**Project: 1B D001FL-Sage FC Sales Center**  
 8152 Fiddler's Creek Parkway  
 Naples, Florida 34114  
 P: 239-307-8826

## Submittal #06 41 00-1.1 - Millwork Cabinets - Shop Drawing 06 41 00 - Architectural Wood Casework

Submittal: SUB-25-1038-002

- DWG 500 | Level 01 - Entry Lobby - Reception Portals and Wall Paneling w/ Door
- DWG 600 | Level 01 - Entry Lobby - Reception Desk
- DWG 601 | Level 01 - Corridors - Material Sample Display w/ Angled Shelving and Drawers

**1D RCP VIEW**  
500A 3/4" = 1'-0" ARCH/D. REF. A-1.00-4

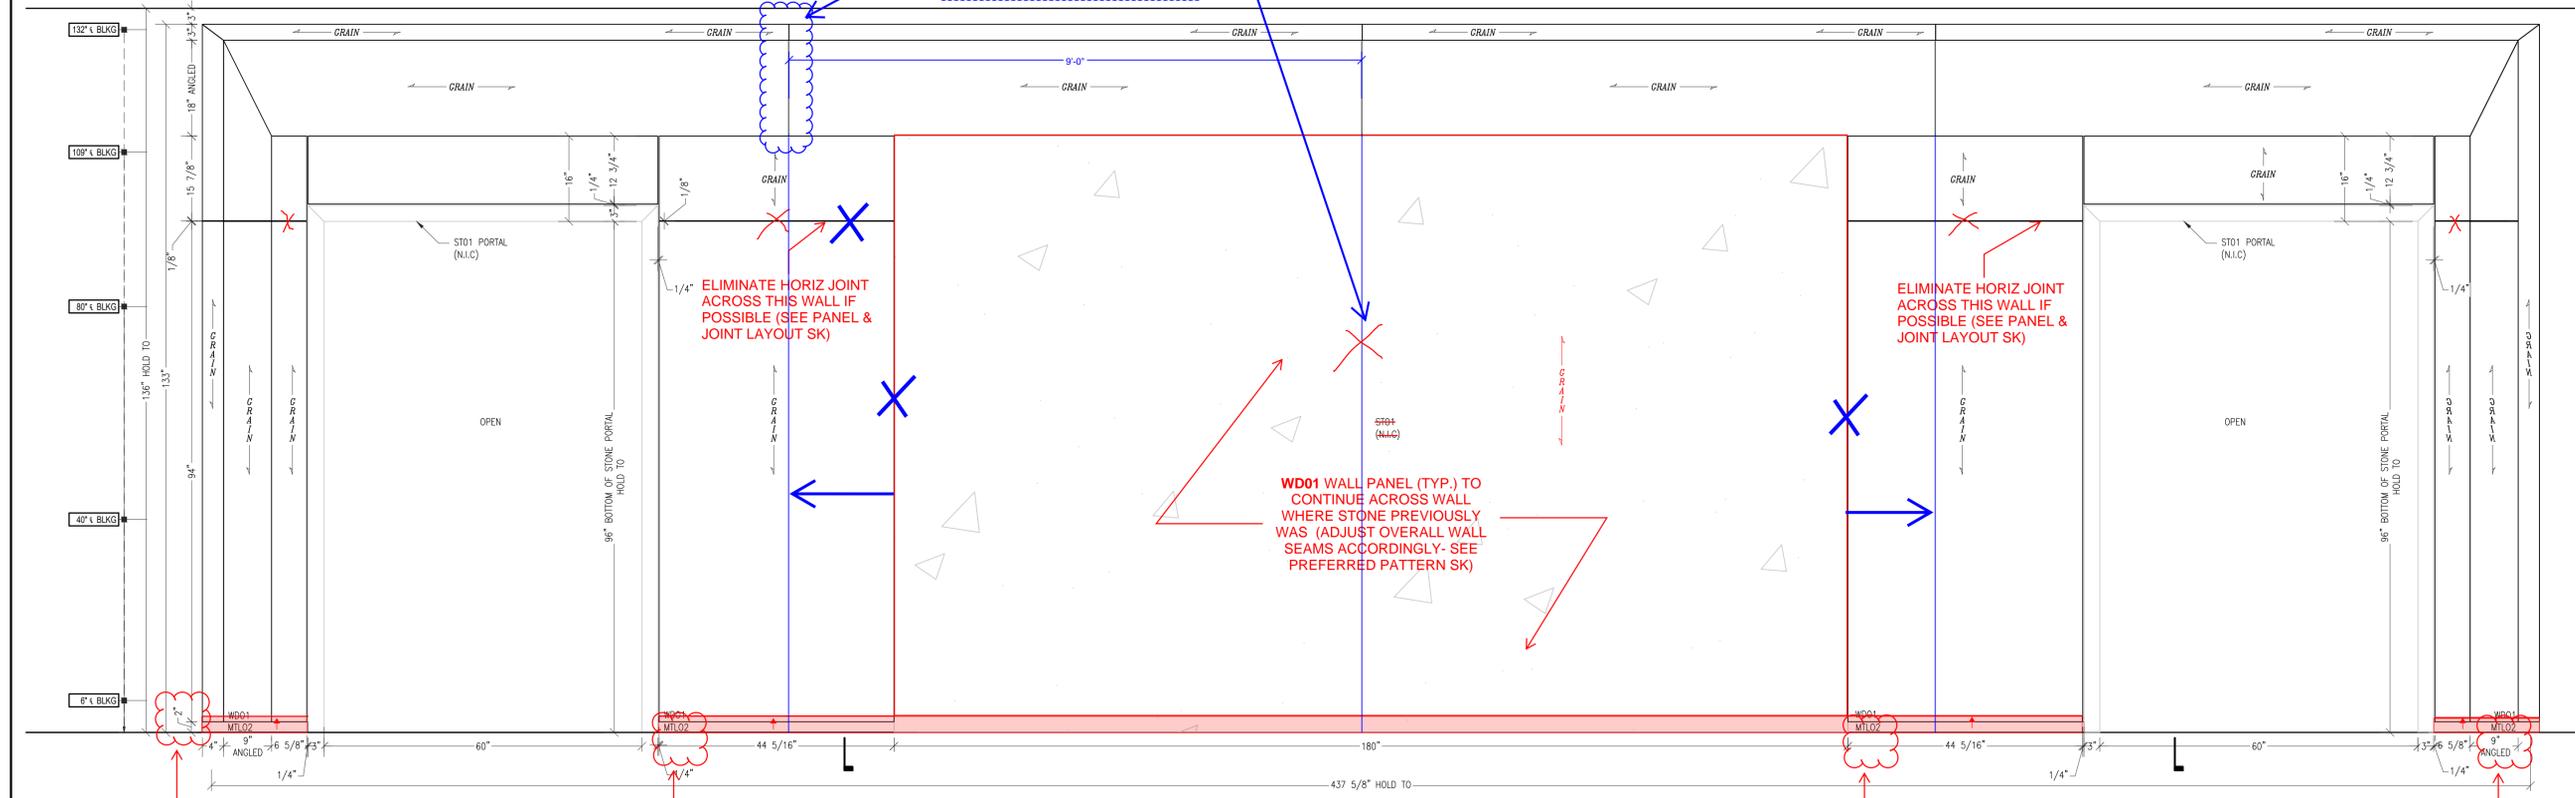
GS: SEAM AT CEILING SHOULD BE BROUGHT DOWN ALONG FACE OF WALL - OWNERSHIP TO CONFIRM SEE NEXT FEW PAGES FOR OWNERSHIP PROVIDED OPTIONS

ELIMINATE HORIZ JOINT ACROSS THIS WALL IF POSSIBLE (SEE PANEL & JOINT LAYOUT SK)

**2 ELEVATION**  
500B 3/4" = 1'-0" ARCH/D. REF. NONE

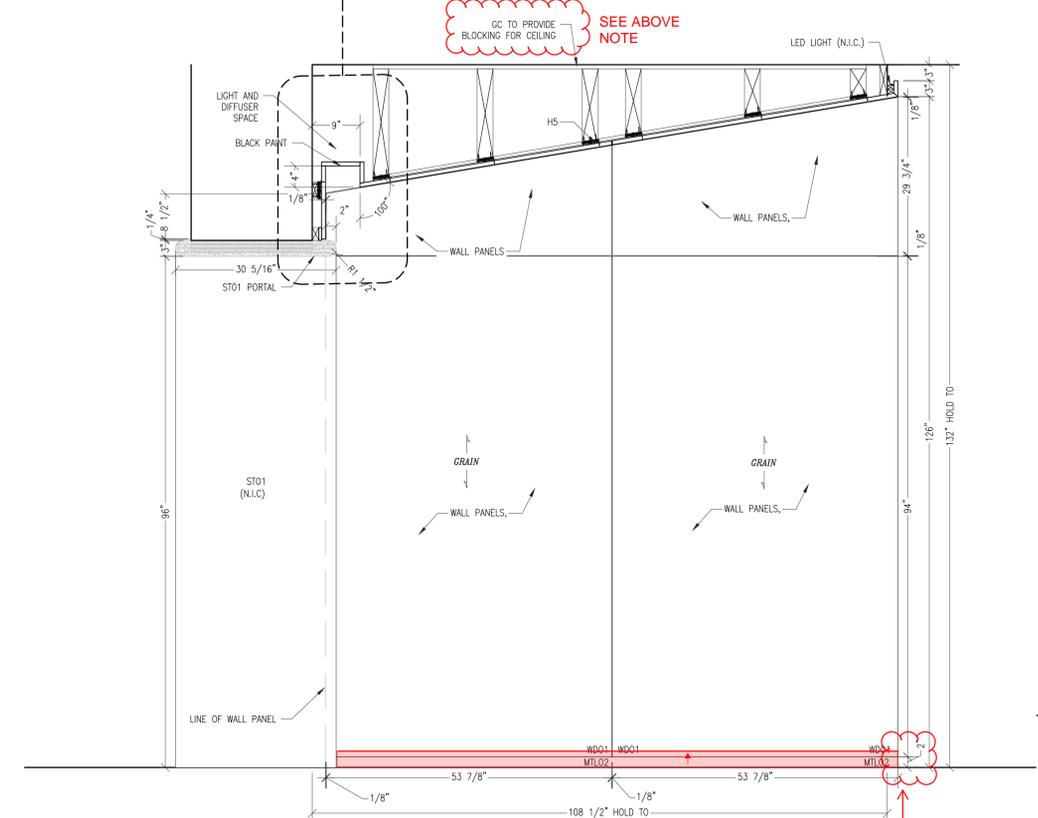
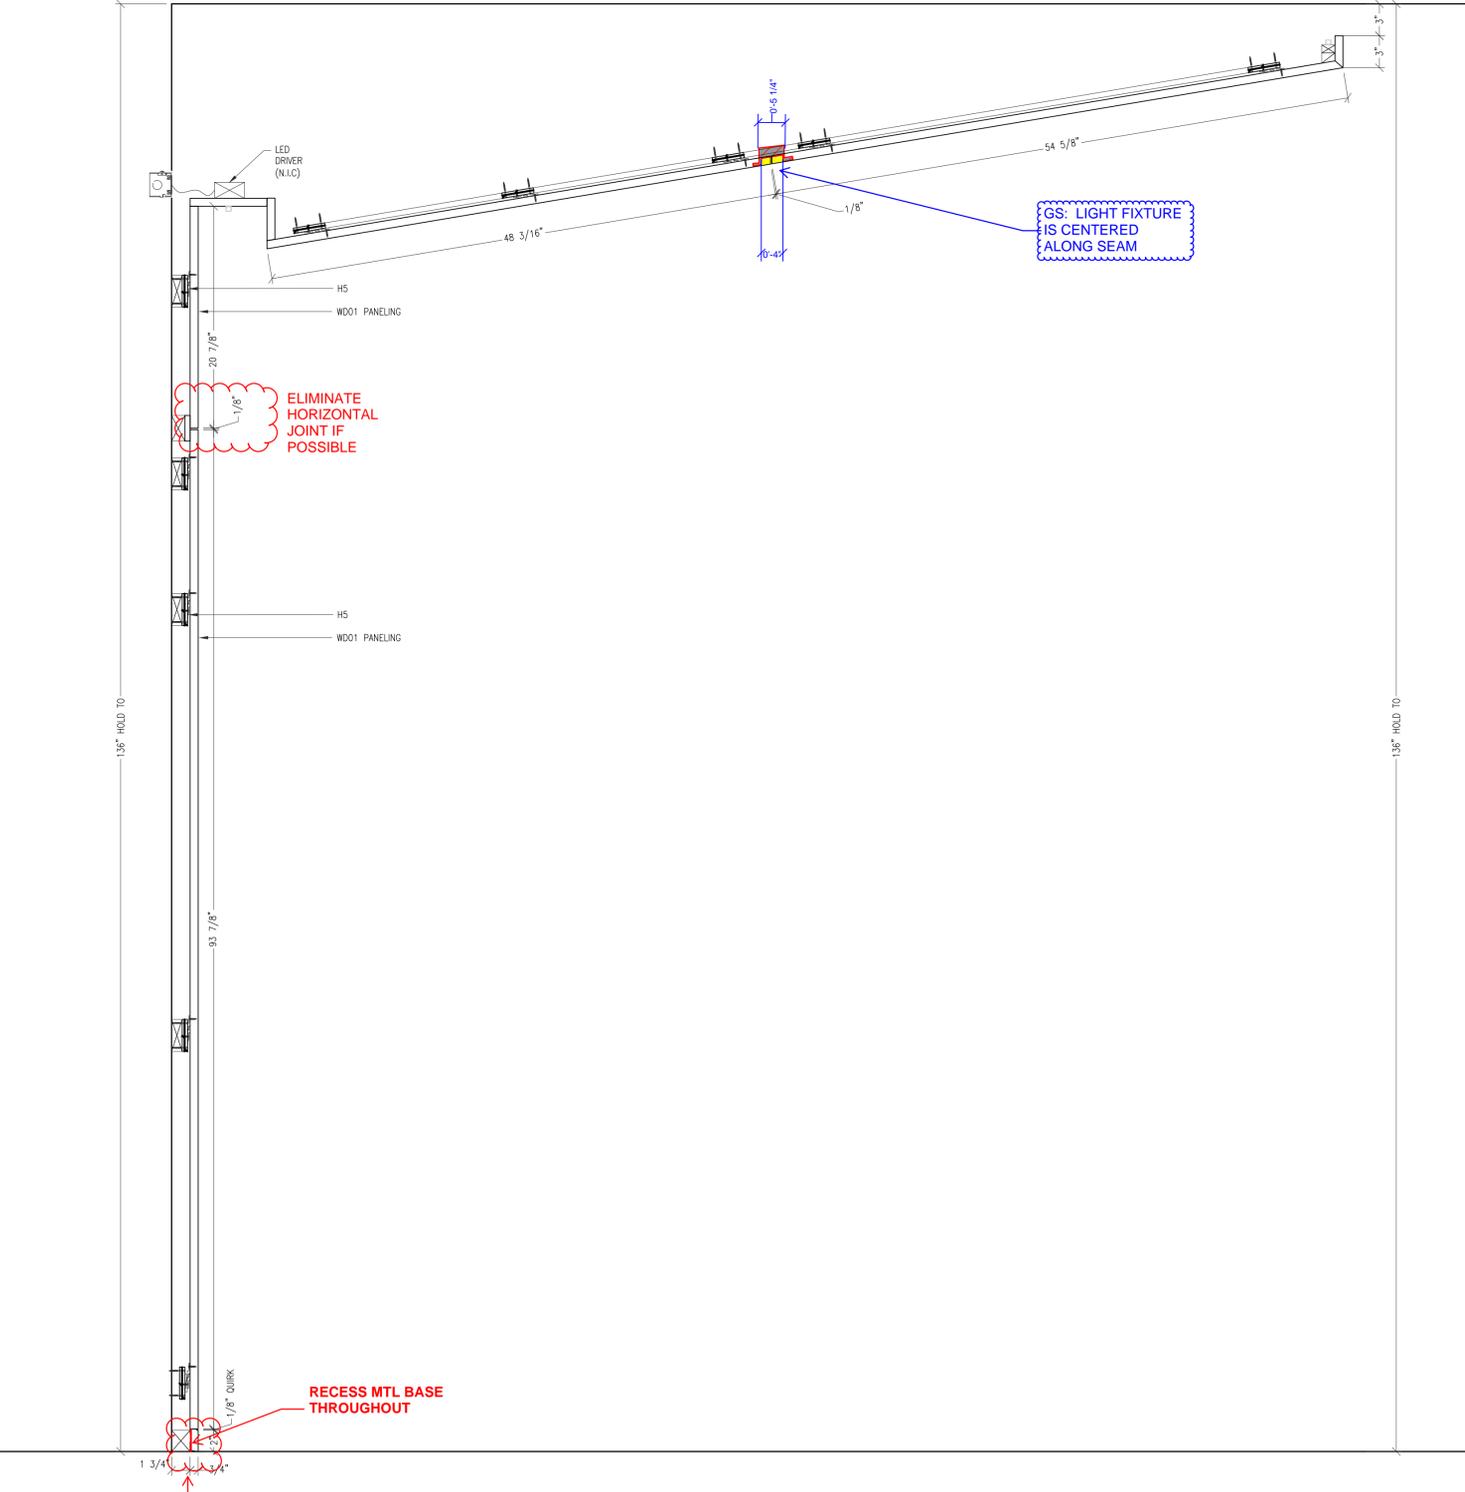
**HW TO PROVIDE DIMENSIONED LOCATIONS OF SUPPORTS SO THAT GC CAN INTALL CEILING PLYWOOD BLOCKING WHILE LEAVING SOME OPEN CEILING FOR MECH/ELECTRICAL**

HW TO PROVIDE DIMENSIONED LOCATIONS OF SUPPORTS SO THAT GC CAN INTALL CEILING PLYWOOD BLOCKING WHILE LEAVING SOME OPEN CEILING FOR MECH/ELECTRICAL

GC TO PROVIDE BLOCKING FOR CEILING

**1C PLAN VIEW**  
602 3/4" = 1'-0" ARCH/D. REF. A-100

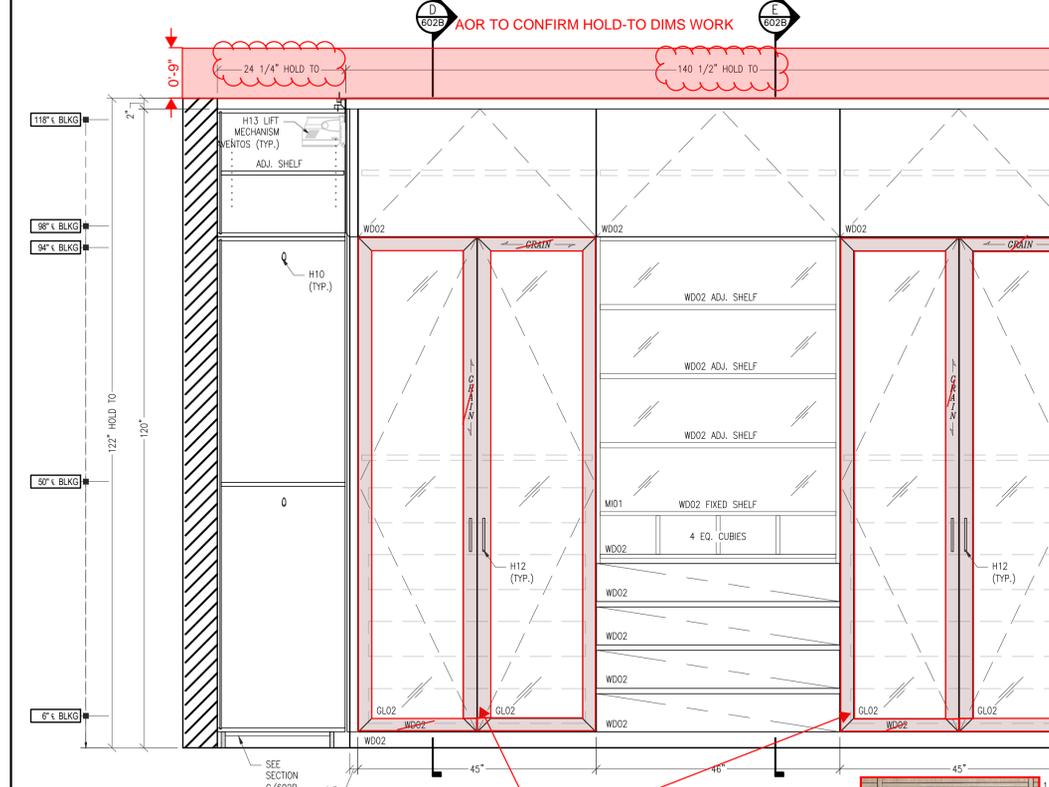
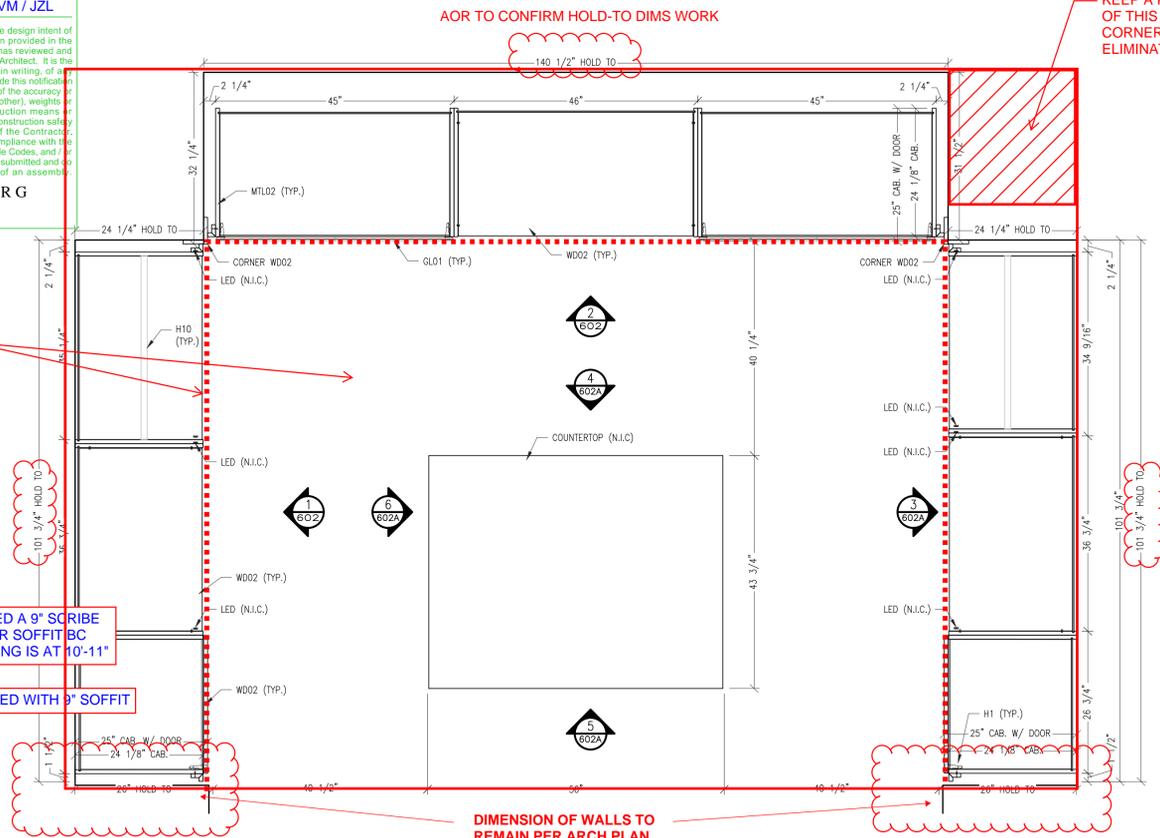
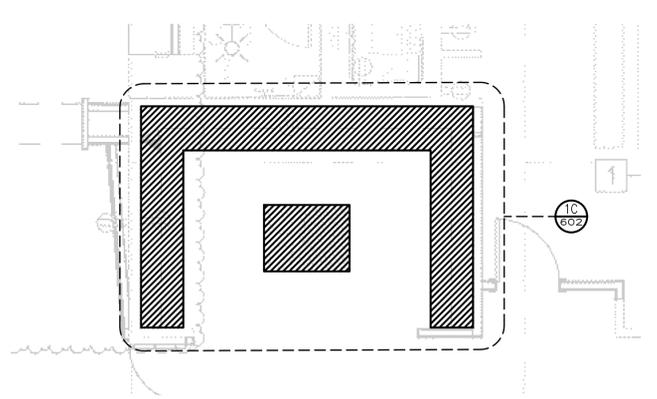
**NOTE:**  
OUTLET REQUIRED FOR EACH DISPLAY (N.I.C)

**CEILINGS & SOFFITS**  
DROPPED SOFFIT OVER PERIMETER MILLWORK TO HOLD-TO DIM. CENTRAL CEILING HEIGHT TO REMAIN AT + 10'-11" AFF PER PLANS

**NOTE:**  
MODIFIED FROM 31" TO 26" (HOLD TO) TO ALLOW DOOR TO HAVE S SLIGHTLY WIDER RADIUS OPENING.
